Form 3160-5
(June 2019)UNITED STATES
DEPARTMENT OF THE INTERIOR
BUREAU OF LAND MANAGEMENTFORM APPROVED
OMB No. 1004-0137
Expires: October 31, 2021**SUNDRY NOTICES AND REPORTS ON WELLS**
Do not use this form for proposals to drill or to re-enter an abandoned well. Use Form 3160-3 (APD) for such proposals.

8. Well Name and No. HAWK 35 FED/406H

EOG respectfully requests an amendment to our approved APD for this well to reflect the following changes:

Hawk 35 Fed 310H (FKA 406H) API #: 30-025-48035

WELL LOCATION AND ACREAGE DEDICATION PLAT

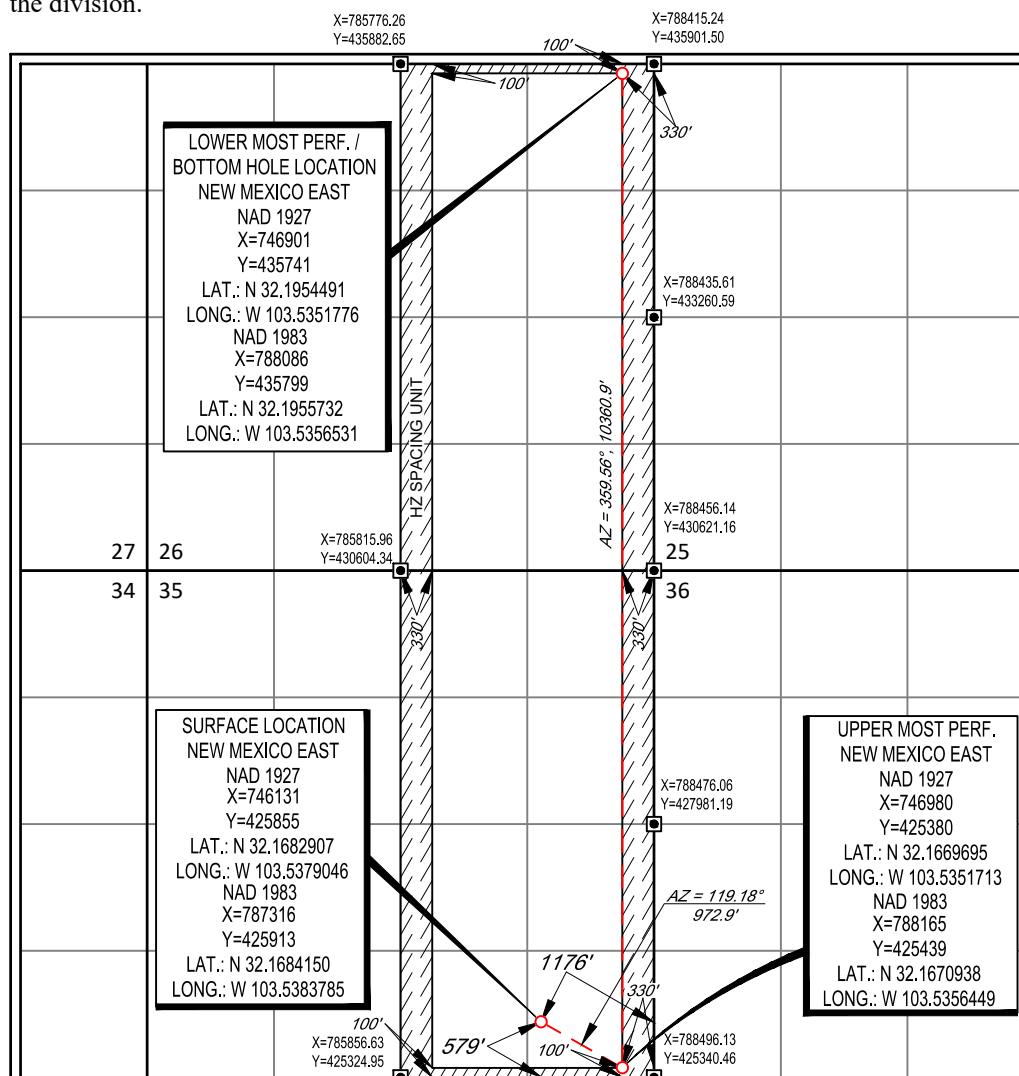
Change name from Hawk 35 Fed 406H to Hawk 35 Fed 310H.

Change SHL from T-24-S, R-33-E, Sec 35, 639' FSL, 1116' FEL, Lea Co., NM, to T-24-S, R-33-E, Sec 35, 579' FSL, 1176' FEL, Lea Co., N.M.

Change BHL from T-24-S, R-33-E, Sec 26, 100' FNL, 1330' FEL, Lea Co., NM, to T-24-S, R-33-E, Sec 26, 100' FNL, 330' FEL, Lea Co., N.M.

UL or lot no.	Section	Township	Range	Lot Idn	Feet from the	North/South line	Feet from the	East/West line	County
P	35	24-S	33-E	—	579'	SOUTH	1176'	EAST	LEA

UL or lot no.	Section	Township	Range	Lot Idn	Feet from the	North/South line	Feet from the	East/West line	County
A	26	24-S	33-E	—	100'	NORTH	330'	EAST	LEA
